## TECHNICAL ADVISORY COMMITTEE

### MINUTES

**ERNIE SOTA, GREEN DEVELOPMENT, INC. / REBECCA FLORA, ReMAKE GROUP  
PROPOSED SUBDIVISION  
CARTER FARM AT CHESTERFIELD AVENUE**

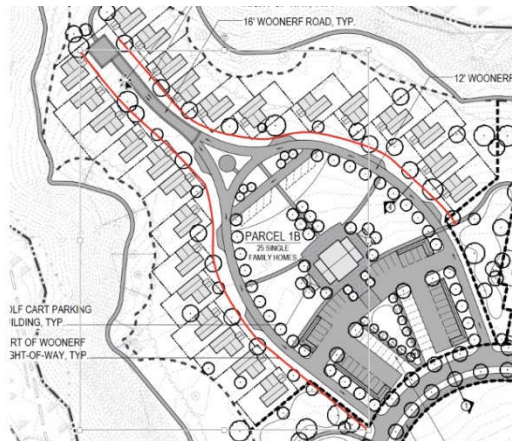
1. The wetland delineation is more than five years old and needs to be updated.
2. CAC would need to determine if they are willing to conduct this as a refinement. This decision is still undecided from CAC.
3. Based on the example below, residential lots are not connected to the public right-of-way and need to be brought up to the streets/woonerfs to provide a seamless line between property line and ROW. The red line below shows how property lines are required to be drawn on the plat.

4. The red line also shows where the woonerf right-of-way is located that differentiates between HOA property maintenance and lot owner property maintenance.
5. Subdivision regulations state that every lot shall front on a street. On Parcel 2, these houses are not fronting a street. A woonerf through Parcel 2 is required to allow for street frontage.
